22.0 REQUIREMENTS RESULTING FROM FUKUSHIMA NEAR-TERM TASK FORCE RECOMMENDATIONS

This FSAR chapter addresses the requirements resulting from the Fukushima Near-Term Task Force (NTTF) recommendations that are applicable to the South Texas Project (STP) Units 3 and 4 Combined License (COL) application. The applicable recommendations address four topics: a reevaluation of the seismic hazard (related to Recommendation 2.1), mitigation strategies for beyond-design-basis external events (related to Recommendation 4.2), spent fuel pool (SFP) instrumentation (related to Recommendation 7.1), and emergency preparedness staffing and communications (related to Recommendation 9.3).

Figure 22.1-6 Comparison of the Horizontal STP Units 3 and 4 Site-Specific SSE—the STP Units 3 and 4 COL Application GMRS—and the Houston Test Site CEUSSSC GMRS

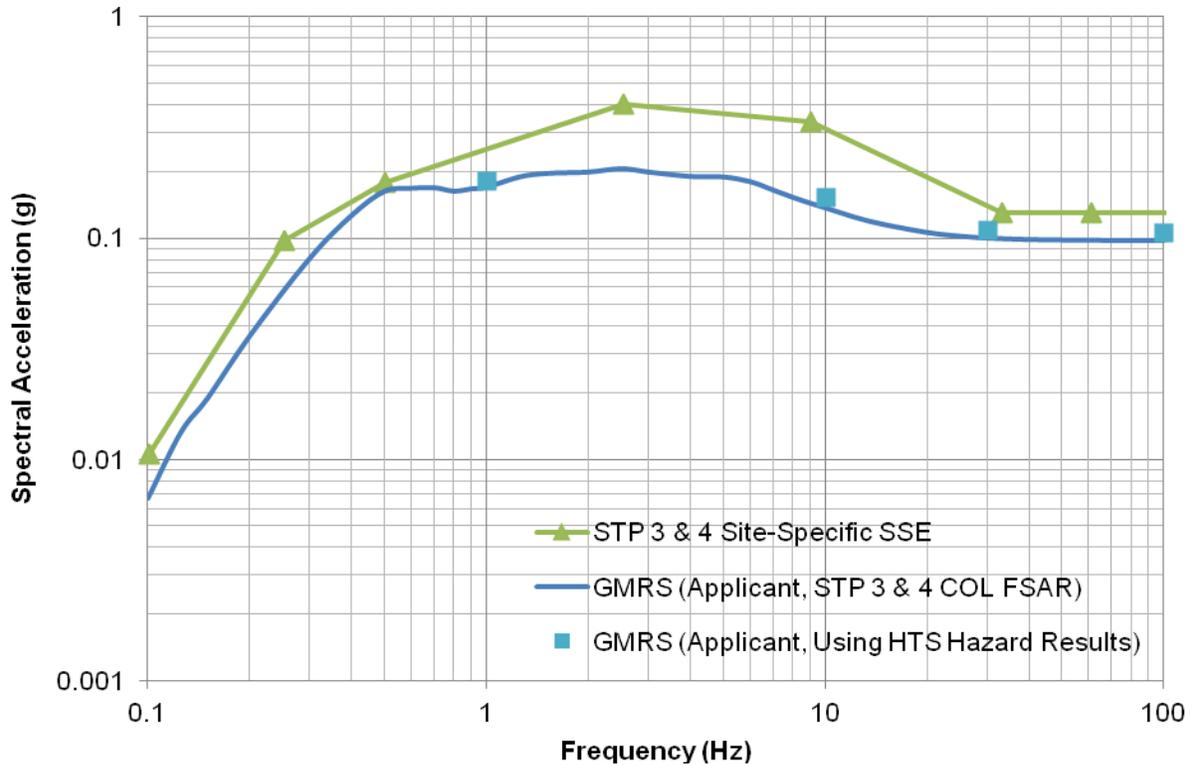
Using the procedure recommended in RG 1.208, the applicant then developed a hard rock GMRS at frequencies of 1, 10, 30, and 100 Hz. Next, the applicant scaled the hard rock GMRS by the STP site-specific amplification factors (i.e., from FSAR Table 2.5S.2-21) at the corresponding frequencies. The applicant's GMRS values are in Figure 22.1-6 of this SER, in addition to the STP COL application GMRS and the STP site-specific safe-shutdown earthquake (SSE) ground motion. Based on this comparison, the applicant concluded that the estimated CEUS-SSC STP GMRS is very close to—and not significantly above—the STP COL application GMRS, while the site-specific SSE envelopes the GMRS from both. The applicant further concluded that because the STP Units 3 and 4 COL application GMRS and the estimated CEUS-SSC results for the STP site are not significantly different, the STP Units 3 and 4 COL seismic design basis does not need to be revised.

Figure 22.1-7 Plot Comparing the Staff's 1-Hz Total Mean Hazard Curves for the Distributed Seismicity Source Zones for the STP Site and the Houston Test Site (HTS). (Also Shown Is the NUREG-2115 1-Hz Total Mean Hazard Curve for the Distributed Seismicity Source Zones for the Houston Test Site)

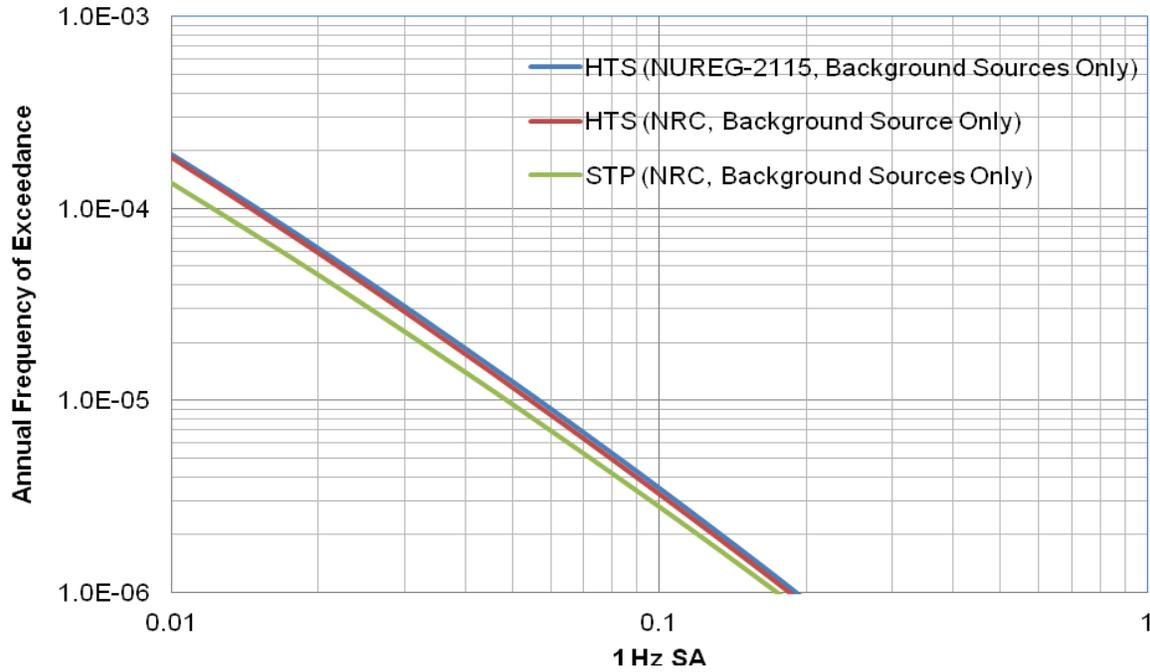
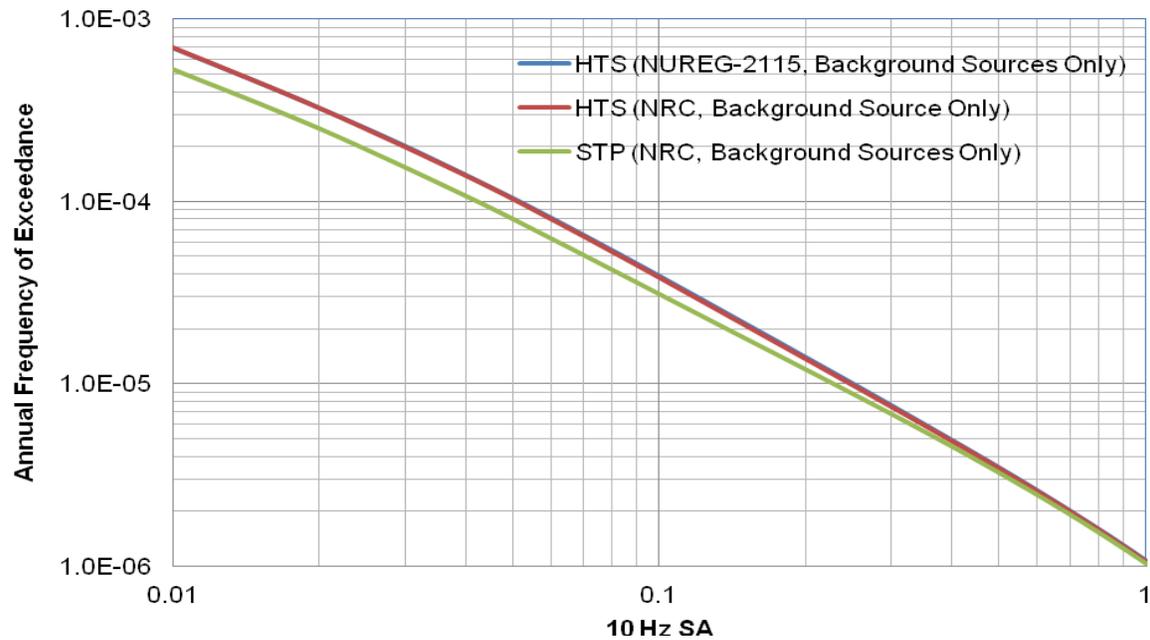
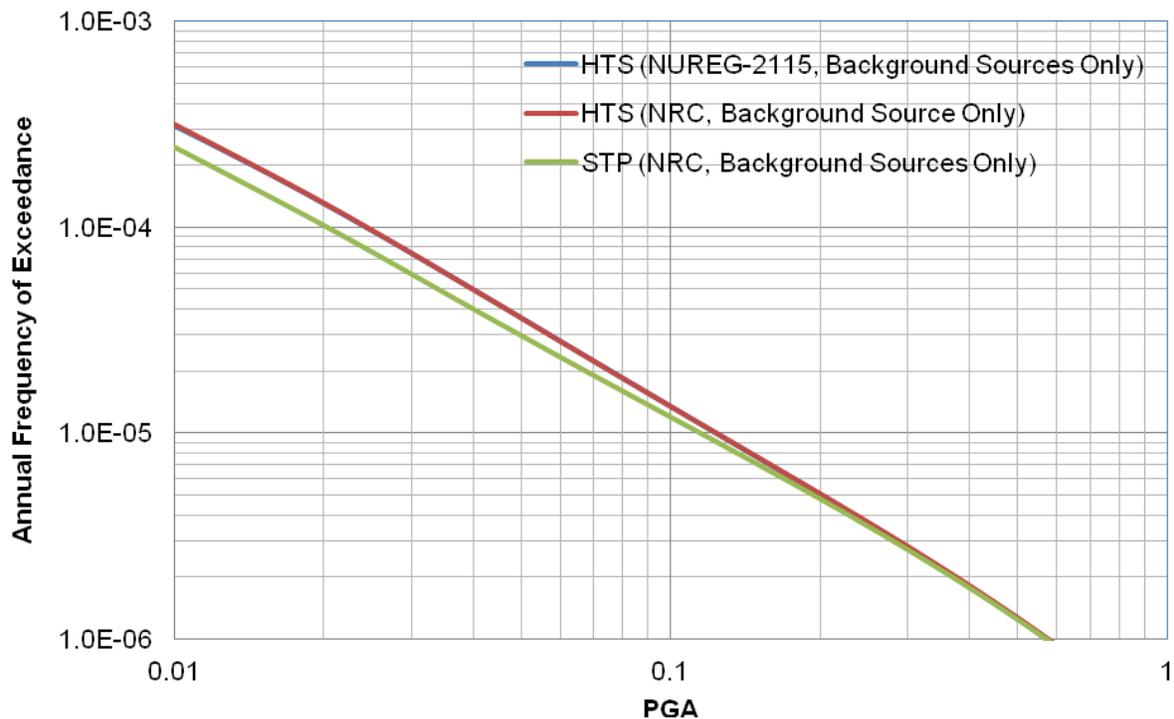
In order to confirm the applicant's assumption that the Houston Test Site hazard curves are appropriate for estimating reference rock seismic hazard curves at the STP site, the staff performed a confirmatory PSHA for the STP site and the Houston Test Site and compared the results with those in NUREG-2115 for the Houston Test Site. The staff used the CEUS-SSC model (NUREG-2115) with the EPRI (2004, 2006) GMM. The staff used the NUREG-2115 Houston Test Site distributed seismicity sources in this confirmatory PSHA. The staff compared the confirmatory 1-, 10-, and 100-Hz hazard curve results for both the STP site and the Houston Test Site with the Houston Test Site results in the NUREG-2115 report for the distributed seismicity sources. The staff determined that the two sets of results are almost identical. This comparison is illustrated in Figures 22.1-7 through 22.1-9 of this SER. The figures show the PSHA hard rock seismic hazard curve results for 1, 10, and 100 Hz, respectively, for the distributed seismicity sources. These figures also show a comparison of the staff's results for the STP site and the Houston Test Site, which indicates that the STP hazard curves are close to or less than the Houston Test Site hazard curves at frequencies of 1, 10, and 100 Hz.

Based on the above assessment, the staff concludes that the COL applicant's use of the NUREG-2115 hazard curves for the Houston Test Site at 1 Hz, 10 Hz, and 100 Hz is an adequate substitute for performing hazard calculations for the STP site using the CEUS-SSC model. Because the RLME sources are quite distant from both the Houston and STP sites, the staff only used the distributed seismicity sources in the confirmatory PSHA analysis. Including

Figure 22.1-10 Comparisons of the Staff's Site Response Amplification Functions with the COL Applicant's Amplification Functions (Taken from FSAR Figures 2.5S.2-39, 2.5S.2-41, 2.5S.2-43, and 2.5S.2-45)

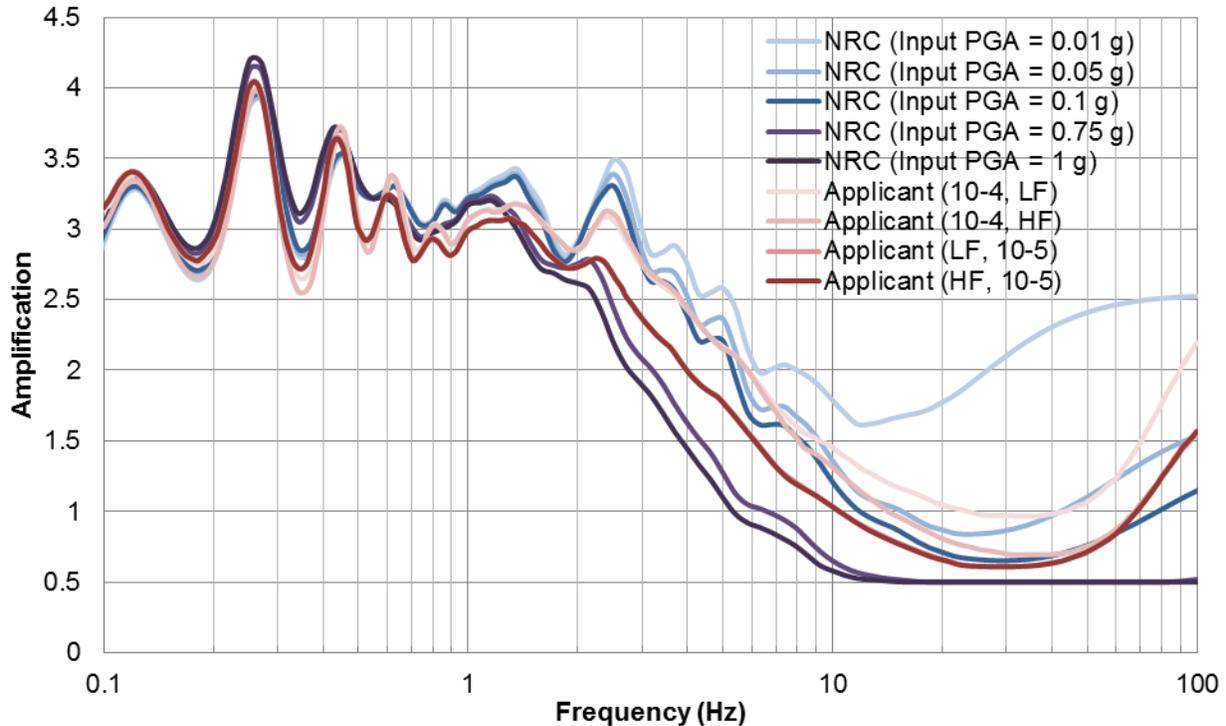
The staff also performed confirmatory site response calculations to determine the adequacy of the applicant's GMRS. For these calculations, the staff used the information on static and dynamic soil properties in COL FSAR Subsection 2.5S.2.5. The staff used 7 spectral frequencies and 11 input rock amplitudes. Figure 22.1-10 of this SER shows a comparison of the staff's mean site amplification function results with the COL applicant's results.

As shown in Figure 22.1-10, the COL applicant's and the staff's results are similar. The staff then used the amplification functions and the CEUS-SSC hard rock hazard curves for the Houston Test Site to develop probabilistic soil hazard curves that adhere to the methodology described in EPRI Technical Report 102587, "Seismic Evaluation Guidance," (EPRI, 2012) and NUREG/CR-6728, "Technical Basis for Revision of Regulatory Guidance on Design Ground Motions: Hazard- and Risk-Consistent Ground Motion Spectra Guidelines," (McGuire, et al., 2001). The staff then developed a GMRS at seven spectral frequencies using an approach that is consistent with RG 1.208. The staff's GMRS is depicted in Figure 22.1-11 of this SER.

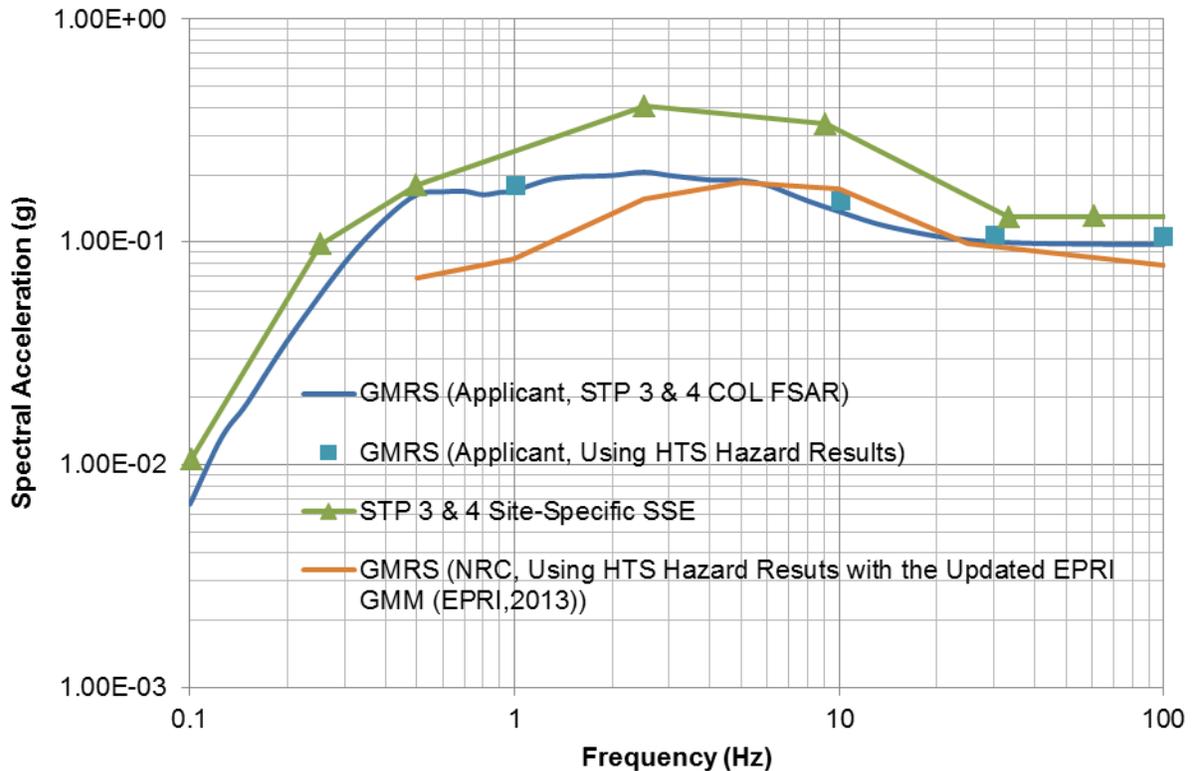
In a letter dated August 28, 2013 (ML13233A102), the NRC stated that the updated GMM is an acceptable model for use by CEUS plants in developing a plant-specific GMRS. The staff calculated the STP GMRS using the CEUS-SSC Houston Test Site hazard results with the Updated EPRI (2004, 2006) GMM (EPRI, 2013). This GMRS is plotted in Figure 22.1-11 of this SER (the light brown curve) and is lower than the STP Units 3 and 4 COL application site-specific GMRS (dark blue curve) for the entire 0.5- to 100-Hz frequency range with the exception of 10 Hz. Although the STP Units 3 and 4 GMRS is exceeded by the staff's CEUS-SSC GMRS at 10 Hz by ~20 percent, the CEUS-SSC GMRS developed by the staff falls well below the STP Units 3 and 4 site-specific SSE. The staff notes that it used a different site response method to develop the CEUS-SSC GMRS than the COL applicant used to develop the STP Units 3 and 4 GMRS. The COL applicant used Approach 2 while the staff used Approach 3, which are described in NUREG/CR-6728. Using either Approach 2 or Approach 3 is consistent with the guidance provided in RG 1.208. Unlike Approach 3, however, Approach 2 does not explicitly incorporate the amplification function uncertainty into the development of the soil UHRS and subsequent GMRS. In a sensitivity calculation, the staff determined that neglecting the amplification function uncertainty resulted in a reduced GMRS across the entire frequency range and at 10 Hz, the STP Units 3 and 4 GMRS is exceeded by the staff's CEUS-SSC GMRS by ~10 percent. In sum, the applicant's GMRS, which is set forth in FSAR Section 2.5S.2.6, and the staff-calculated GRMS are within the limits of uncertainty, and both sets of results are bounded by the site-specific SSE. Based on the above comparison, the staff accepts the applicant's decision not to update the STP Units 3 and 4 COL application site-specific GMRS and its site-specific SSE.

3. The staff’s site-specific GMRS, which is based on the CEUS-SSC model used for the Houston Test Site and the Updated EPRI (2004, 2006) GMM, is well below the STP Units 3 and 4 COL FSAR GMRS calculated by the applicant using the updated EPRI-SOG model for the entire 0.5- to 100-Hz frequency range with the exception of 10 Hz. The staff concludes that the ~20 percent exceedance of the STP Units 3 and 4 GMRS by the staff’s

CEUS-SSC GMRS at 10 Hz is within the limits of uncertainties. Therefore, no revisions to the STP Units 3 and 4 COL FSAR GMRS are necessary.
